Commonwealth Edison

September 30, 1983

Subject: Braidwood Station Units 1 and 2
Response to Unresolved Issues Contained
In Draft SER-NUREG 1002
NRC Docket Nos. 50-456/457

Commonwealth Edison Company
Response to the Open Items Contained in the Braidwood
Draft SER-NUREG 1002 dated July 15, 1983

FIGURE 13.1-1

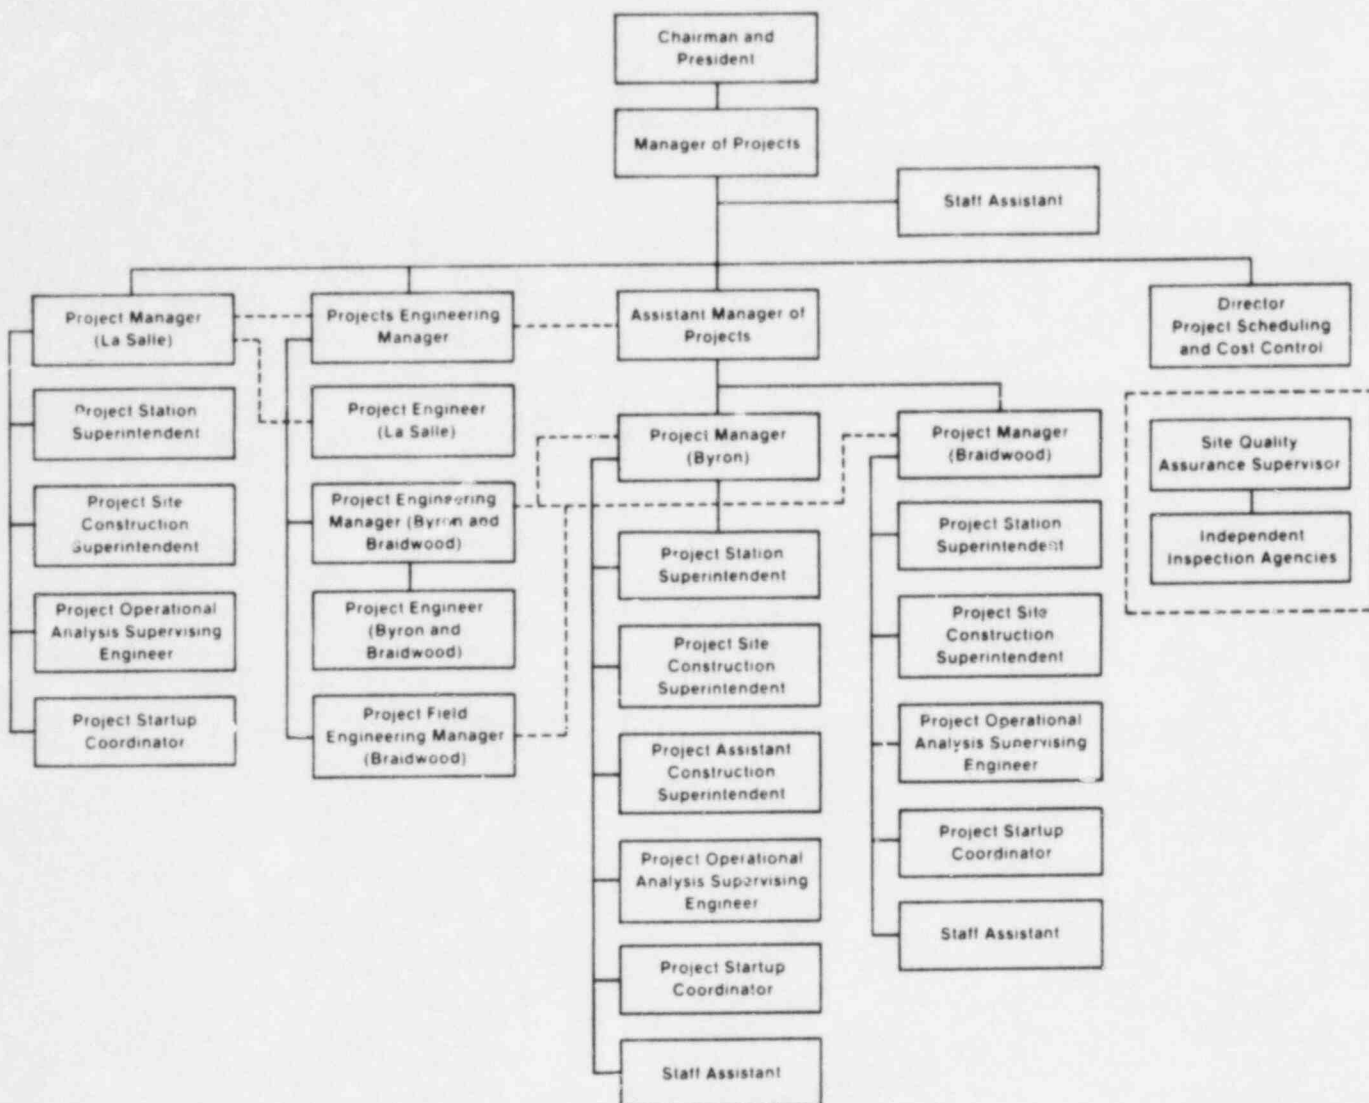
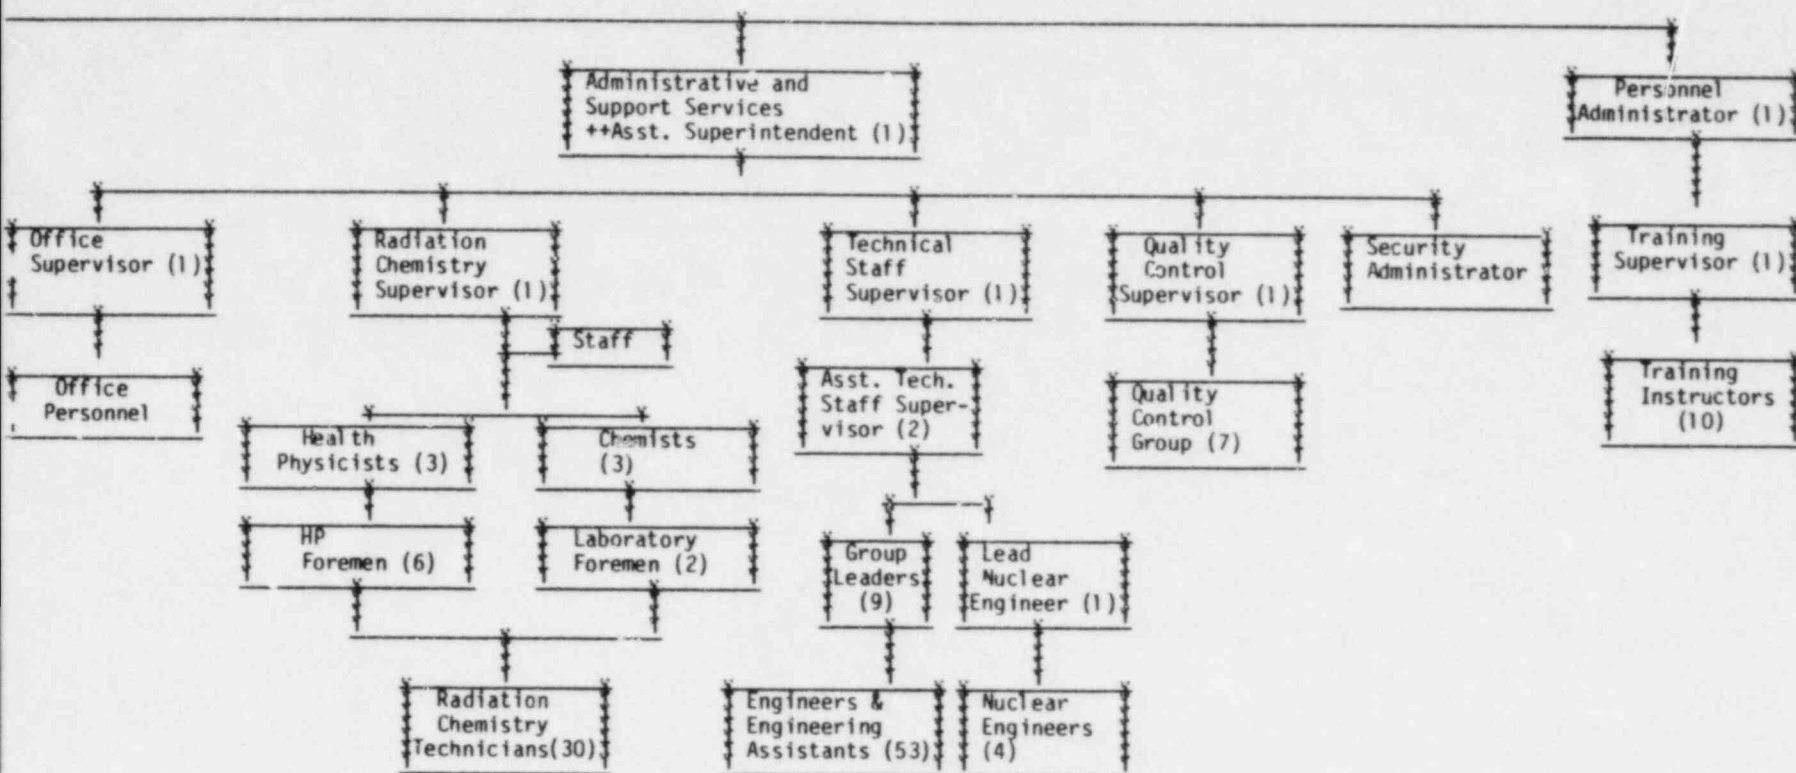
(5) Personnel on Shift with Previous Commerical PWR Experience During Startup Phase - Section 13.1.2.1*

Figure 13.1-1 has been revised to reflect the current Project Management Organization and has been provided in Amendment No. 43 to the FSAR. A copy of same is attached for convenient reference. The current revision of the Commonwealth Edison Company QA Topical Report CE-1A is Revision No. 25. The Braidwood Station organization is described on the attached Figure 13.1. Reporting directly to the Station Superintendent are the Maintenance Assistant Superintendent, the Operating Assistant Superintendent, the Administrative and Support Services Assistant Superintendent, and the Personnel Administrator. The Site Quality Assurance Group is independent (not shown on Figure 13.1) of the operating organization and reports directly to the Director of Quality Assurance (Operations) offsite as described in Topical Report CE-1A, Revision 25. The plant staff presently consists of about 246 individuals with a projected number of 500 individuals by the Unit 1 fuel load date.
